PROJECT REVIEW REPORT

Project ID	2610
Project Name	Unitán Afforestation and Reforestation of grazing lands project
Review Type	Verification
Program(s)	VCS
Verification Period	16 August 2021 to 09 August 2024
Project Proponent	Unitán SAICA
Methodology	AR-ACM0003, Afforestation and reforestation of lands except wetlands, v02.0
VVB	Colombian Institute for Technical Standards and Certification – ICONTEC
Assessment Criteria	VCS Standard, V4.7
Date of First Issue	29 May 2025
Date of Second Issue	27 October 2025
Review Conclusion	Approved
Date of Final Issue	23 December 2025

Image from 12/18/2018

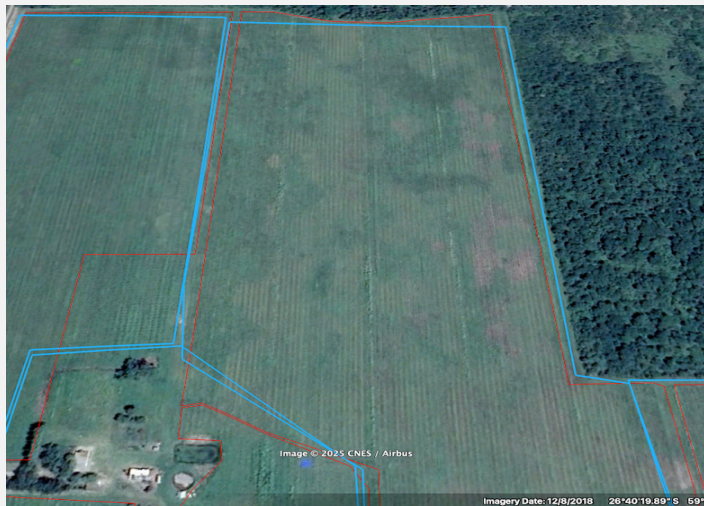
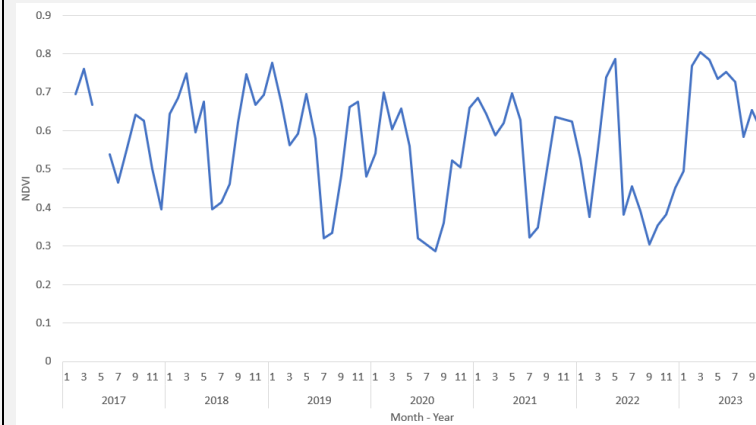
2 Missing information on carbon loss			
	<p><u>Issue</u></p> <ol style="list-style-type: none"> 1. Satellite imagery shows vegetation cover loss in project area polygons other than the Ex-Glombowsky farm in Puerto Tirol, which was reported in the loss event report (see background). Further information is needed to understand the impact of this loss. <p><u>Action Required</u></p> <ol style="list-style-type: none"> 1. The VVB must ensure the PP updates the MR to: <ol style="list-style-type: none"> a. Describe the observed vegetation cover loss and estimate the associated emissions. b. Adjust the net GHG ERRs for the monitoring period accordingly, whether it occurred during or after the monitoring period. c. Duly consider this event as a potential risk to the project in the non-permanence risk report and adjust the monitoring plan as needed. 2. The VVB must ensure that the PP provides either of the following: <ol style="list-style-type: none"> a. Demonstration that the event does not qualify as a Loss Event (see the <i>VCS Program Definitions</i>). b. If the event qualifies as a Loss Event (see the <i>VCS Program Definitions</i>), the PP must: <ol style="list-style-type: none"> i. Follow the loss event reporting requirements set out in Section 5.3.1 – 5.3.3 of the VCS 	<p>Round 1</p> <p><u>VVB Response</u></p> <p>In accordance with issue 1, the PP justified the following information:</p> <p>Through NDVI analysis, it was verified that the area of the Pampa Almirón farm (proposed in these findings) does not represent a case of cover loss, but rather a change in biomass productivity due to seasonal temperature and humidity (see photos in the Findings 2 folder). The area was planted with <i>Schinopsis balansae</i> in 2016 and 2017, but given the slow growth rate of native species, the color (or NDVI) observed in the satellite images presented in this finding corresponds to that of herbaceous plants and not that of the planted trees.</p> <p>An NDVI analysis conducted for the plot area revealed these seasonal changes in productivity. The NDVI time series was obtained from the Landsat 8 and 9 datasets using a Google Earth Engine script. The script masks cloudy pixels and obtains the mean NDVI for plot 33 for each Landsat image. The result was the mean cloud-free NDVI time series. The time series shows the intra-annual vegetation pattern, with June, July, and August showing the lowest NDVI values. Depending on the meteorological conditions of the year, the low values could extend into spring (September to December), as was the case in</p>	<p>Closed</p>

Satellite imagery from Google Earth Pro at approximately S26° 40'28.90" and W59° 06'10.28" indicates vegetation cover loss in portions of the project area occurring after the project start date.

This corroborated that the satellite images presented in the finding do not depict a loss of vegetation cover in polygons within the project area; thus, the 2022 and 2023 wildfires occurred only on the Ex-Glombovsky farm, as described in MR.
